SSDA RESPONSE TO SUBMISSIONS REPORT

MELROSE PARK SOUTH – EAST – BLOCK 05

REPORT PREPARED BY FK ON BEHALF OF WHARF AND HUGHES DEVELOPMENTS PTY LTD

JAN 2026

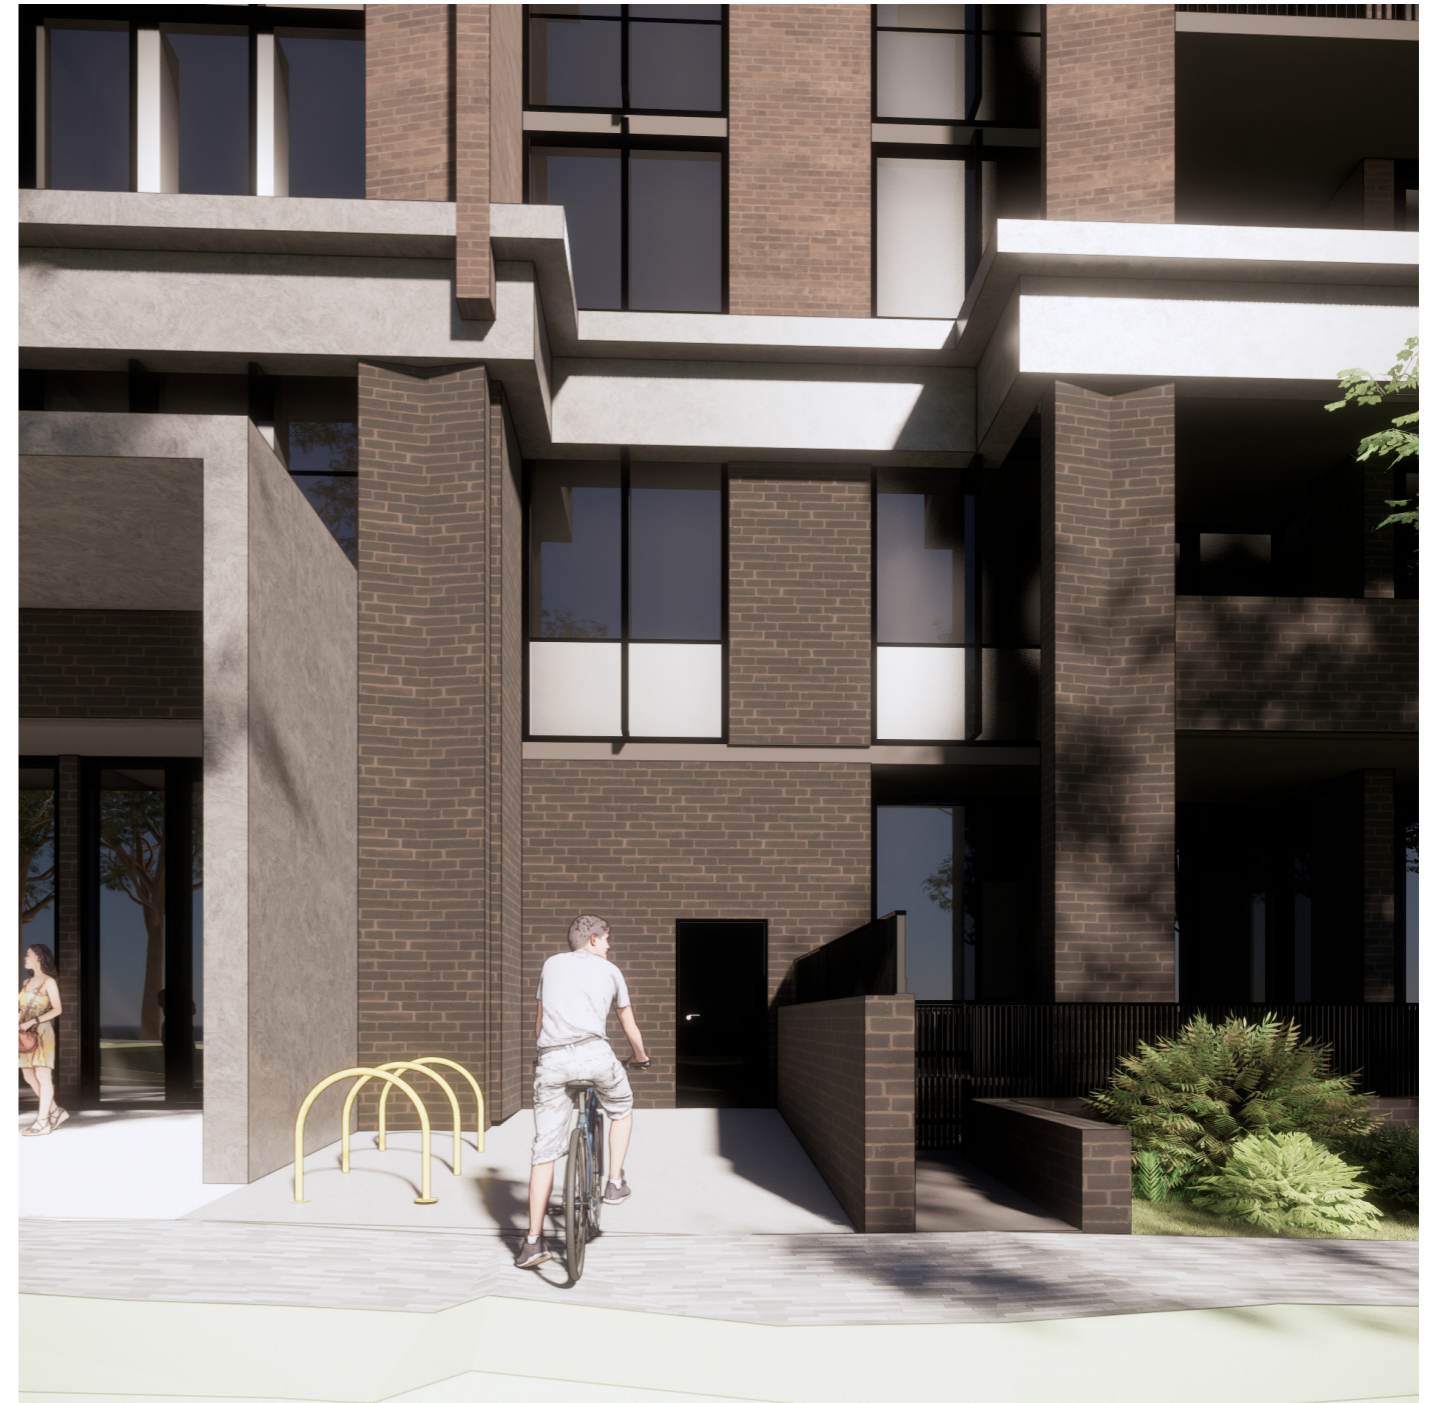
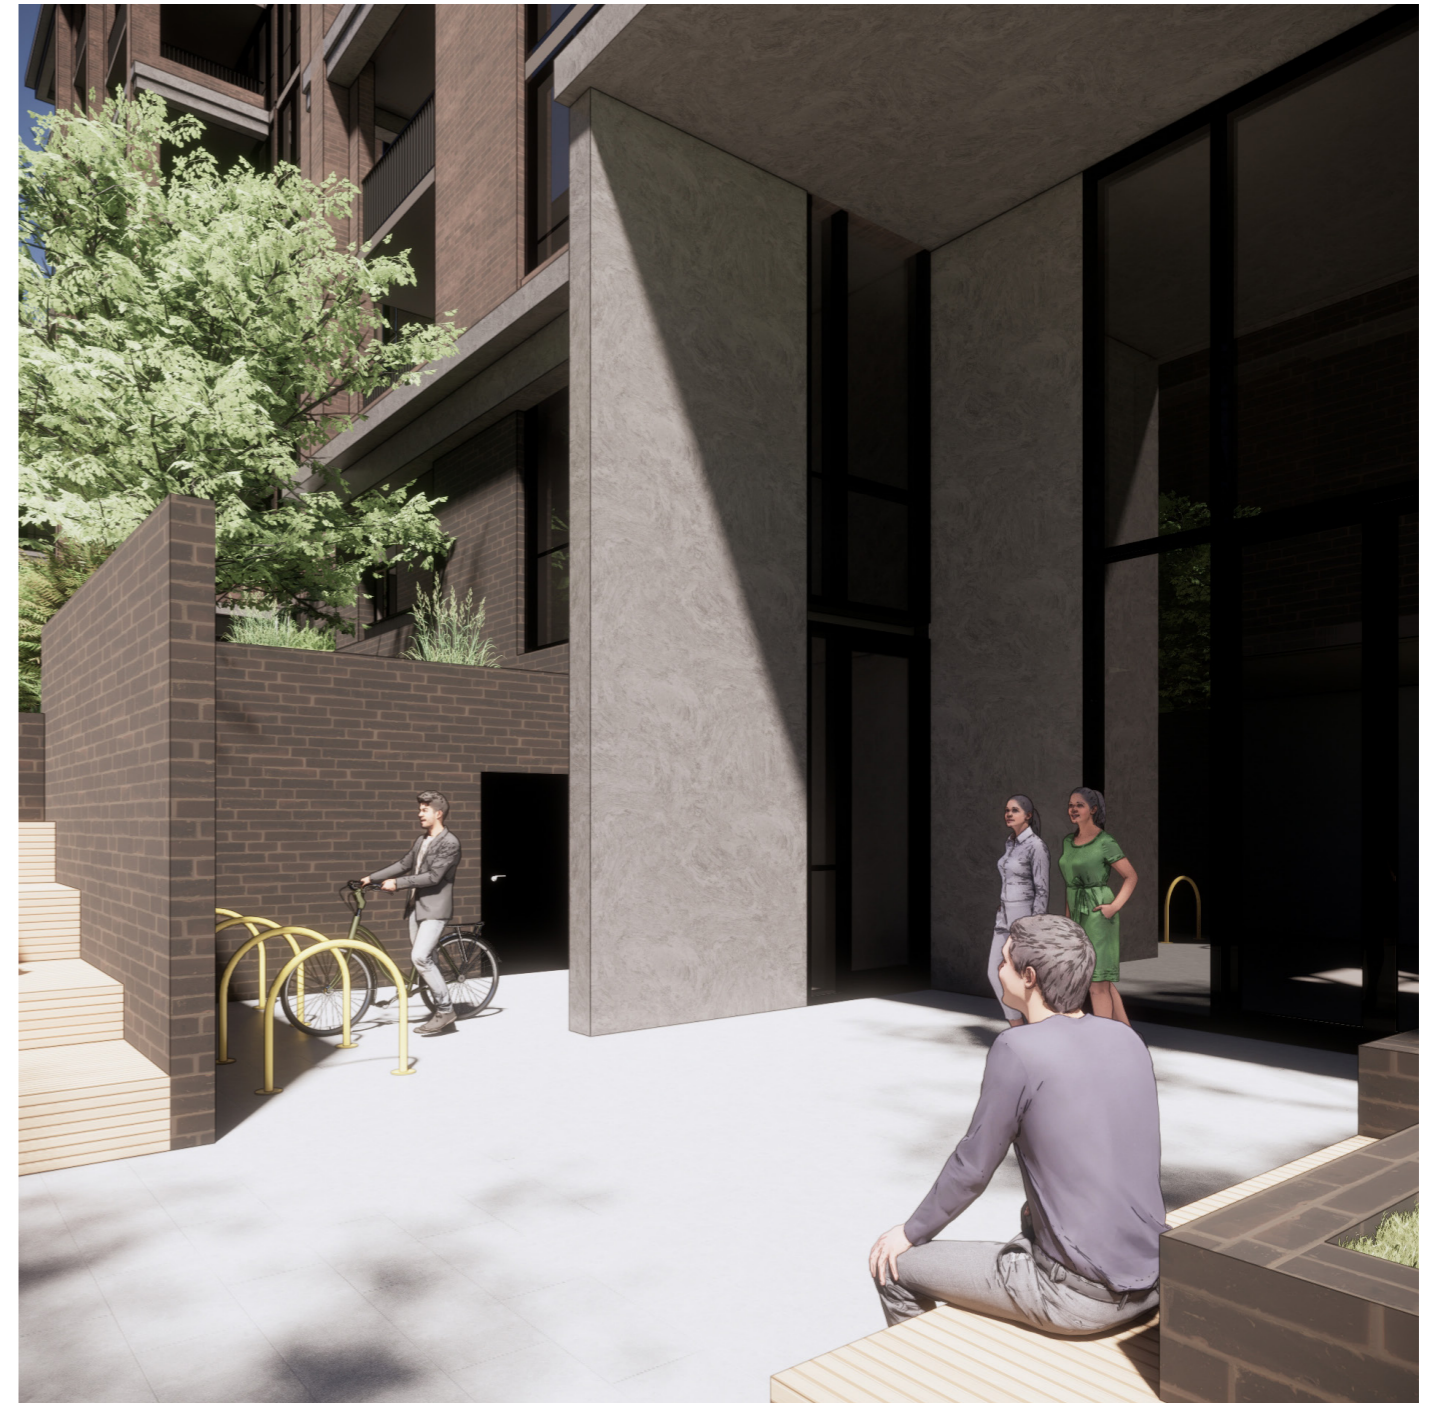
- The two banks of bicycle parking along the western elevation appear to block the NW entry in the one case, and impact on the visual and physical amenity of the private open space of an adjacent street facing apartment in the other. Both of these bicycle parking locations appear not to be suitable and should be relocated.

- Refer to Landscape architect for responses to planter levels, Integrated seating and rooftop terrace design amendments.
- See the following pages demonstrating improved bicycle parking solutions for the public domain ensuring residential amenity.

The bicycle parking located adjacent to the NW lobby does not obstruct the NW entry. The entry is located on the side elevation rather than the street frontage, and clear, unobstructed access is maintained at all times.

The bicycle parking associated with the SW area has been relocated away from the adjacent street-facing apartment to minimise visual impact and avoid any physical encroachment on the private open space.

The visitor bicycle parking adjacent to the NE lobby does not impact apartment privacy.

The visitor bicycle parking adjacent to the SE lobby does not impact apartment privacy.
